**Re: Pio Pico Energy Center Project (11-AFC-01)
Supplemental Responses to Data Requests BIO-29 and BIO-30**

**PIO PICO ENERGY CENTER PROJECT
11-AFC-01**

**Supplemental Responses to BIO-29 and BIO-30
Responses to Ann Crisp's August 2, 2011 Email Correspondence**

REV. FIGURE DR-BIO 29.1
CUMULATIVE NITROGEN DEPOSITION,
INCLUDING PROJECT CONTRIBUTION
(UNITS OF KG/HA/YR)

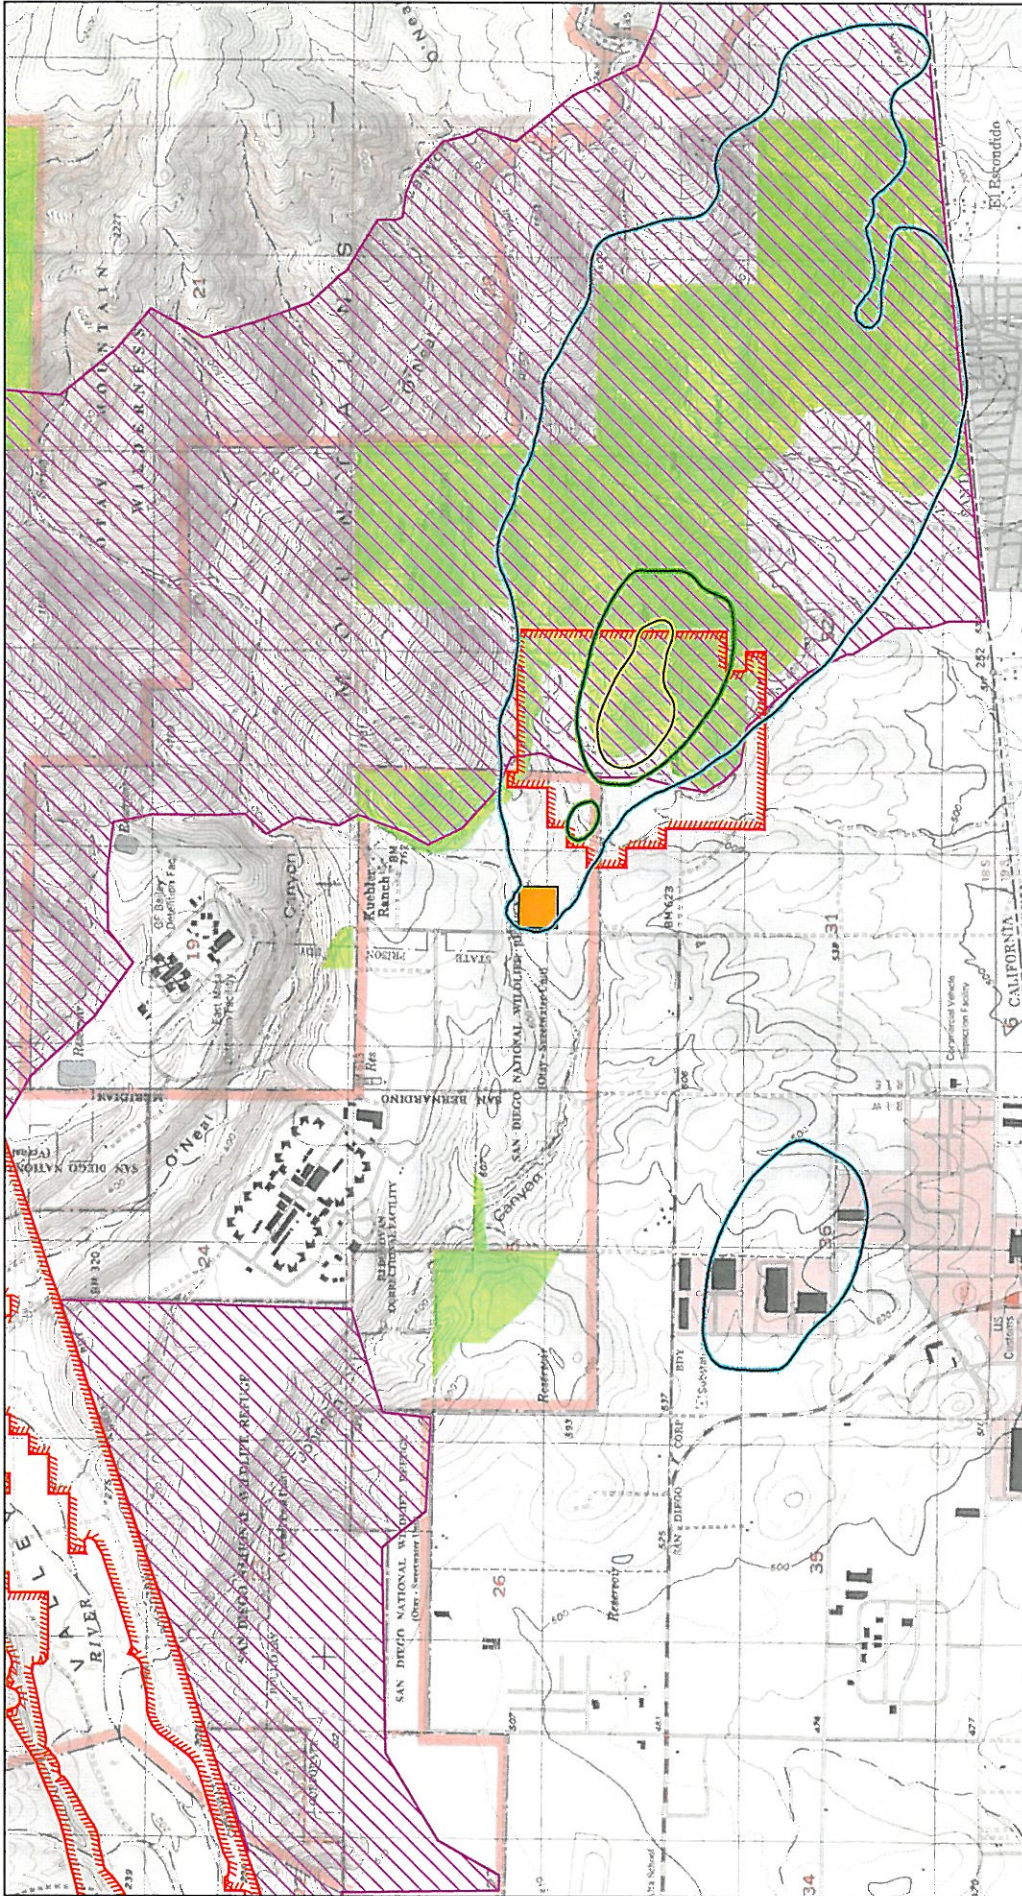
2. What does the 13.0, 15.0 and 17.0 kg/ha represent? Is this baseline plus additional regional sources? Also what does the 19 kg/ha represent?
As requested by the CEC staff, we calculated cumulative impact by adding the modeled impact from the project and non-project sources to the staff-specified regional background rate of 11.56 kg/ha/yr. The isopleths are lines connecting points where the cumulative impact has the specified value. The 19 kg/ha point is the modeled maximum cumulative impact in the area that the figure represents.

3. The map states kg/ha - is this actually kg/ha/yr?
Yes

4. Please identify the sources of the data layers, including the sources for critical habitat for species. I believe the map does not show the revised Quino checkerspot butterfly critical habitat from 2009 but the original 2002 Quino critical habitat designation.
The habitat and species source data is provided below:

- Otay Tarplant: U.S. Fish and Wildlife Service, Carlsbad Fish and Wildlife Final Critical Habitat for the Otay tarplant, December 10, 2002.
 - CA Gnatcatcher: U.S. Fish and Wildlife Service, Carlsbad Fish and Wildlife Final Critical Habitat for the Coastal California gnatcatcher, December 19, 2007.**Furthermore, Figures 29.1 and 29.2 have been revised based on the 2009 Quino Checkerspot Butterfly data and are submitted herewith.**

PROJECT DR-BIO 29.3
 PROJECT CONTRIBUTION AS A PERCENTAGE OF TOTAL CUMULATIVE NITROGEN DEPOSITION (UNITS OF PERCENT)

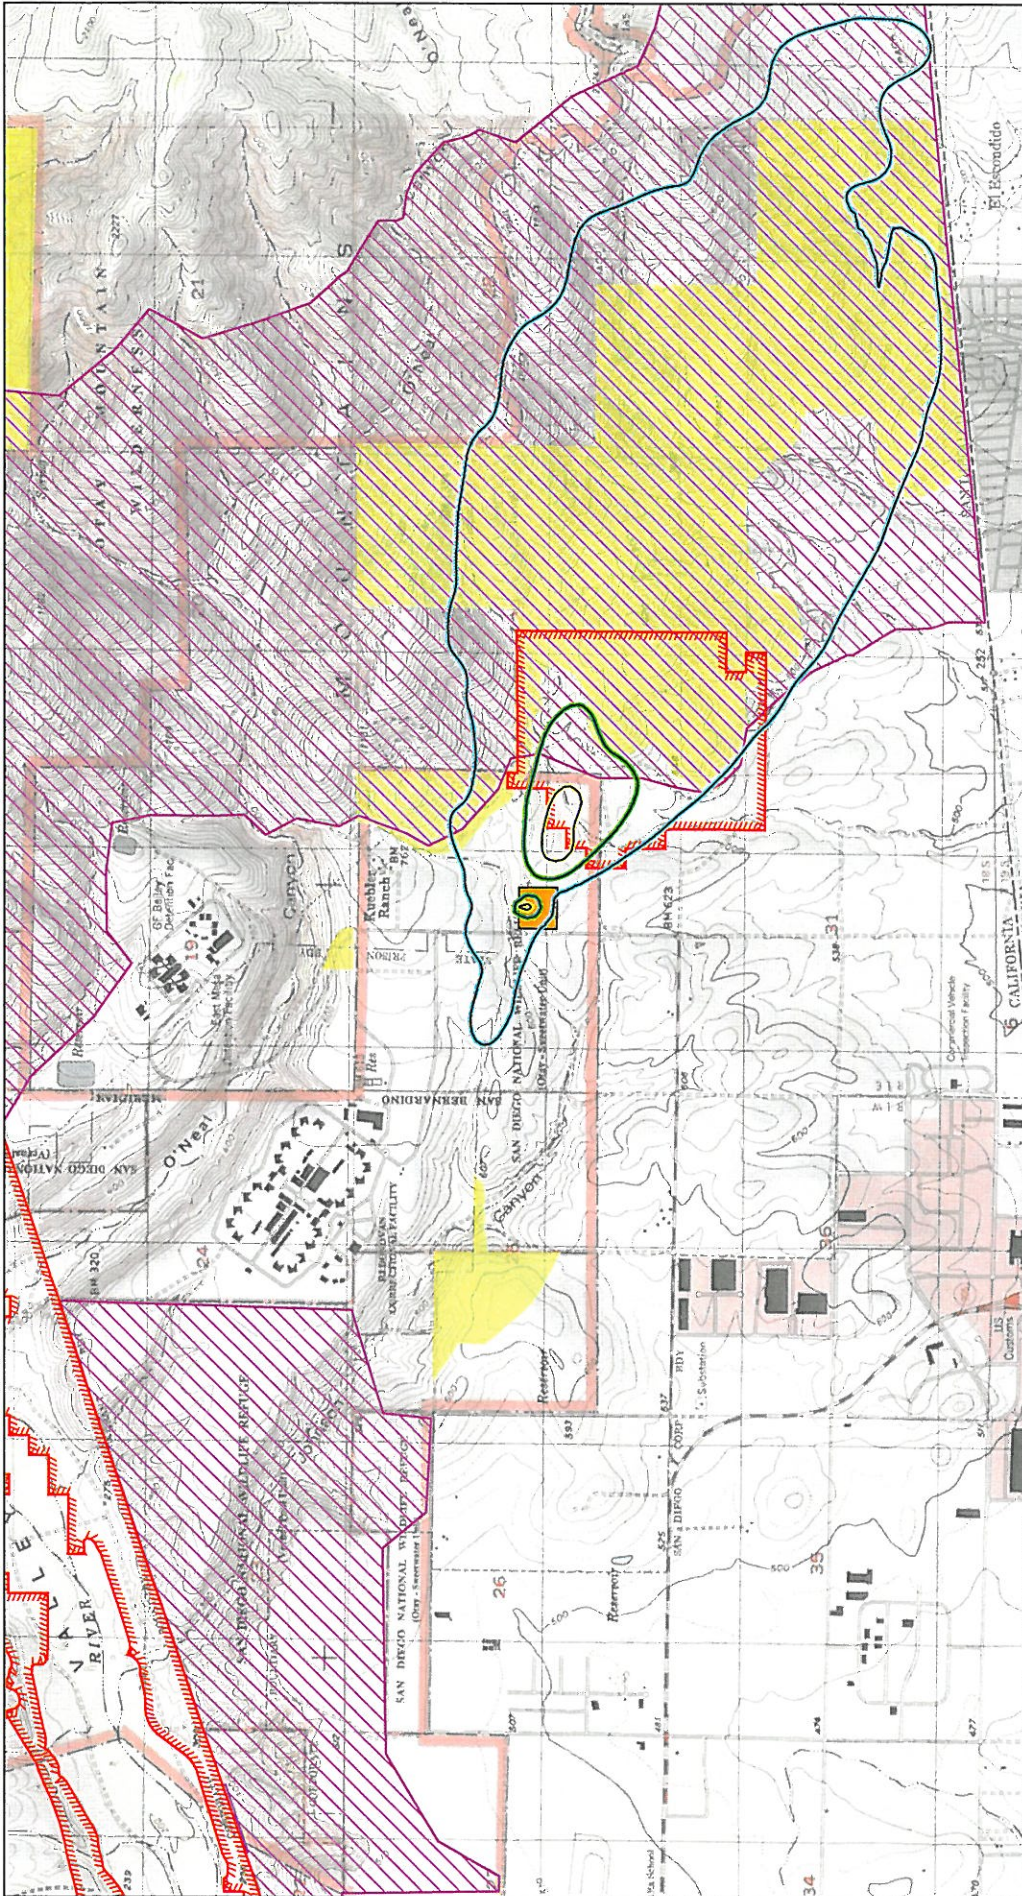
6. How was the 6% contribution calculated?

The 6% represents the approximate average of the Project's contribution to the cumulative impact as a percentage on USFWS critical habitat for the Quino Checkerspot Butterfly. This value was taken from Figure 29.3 which has not been previously provided and represents the values (as a percentages) of the Project's contribution in relation to the location of USFWS critical habitat for Quino Checkerspot Butterfly.

Figure 29.3 shows the Project's contribution (expressed as a percentage) to the total cumulative impact. The values shown in Figure 29.3 were calculated using a spreadsheet containing output from the nitrogen deposition model (AERMOD, using appropriate options). The project's impact at each receptor in the modeling domain was divided by the total cumulative impact at that receptor, and the result converted to a percentage. The contribution in the area represented by Figure 29.3 ranged from close to zero (throughout most of the region) to a maximum of 10.9% (at the project's point of maximum impact).
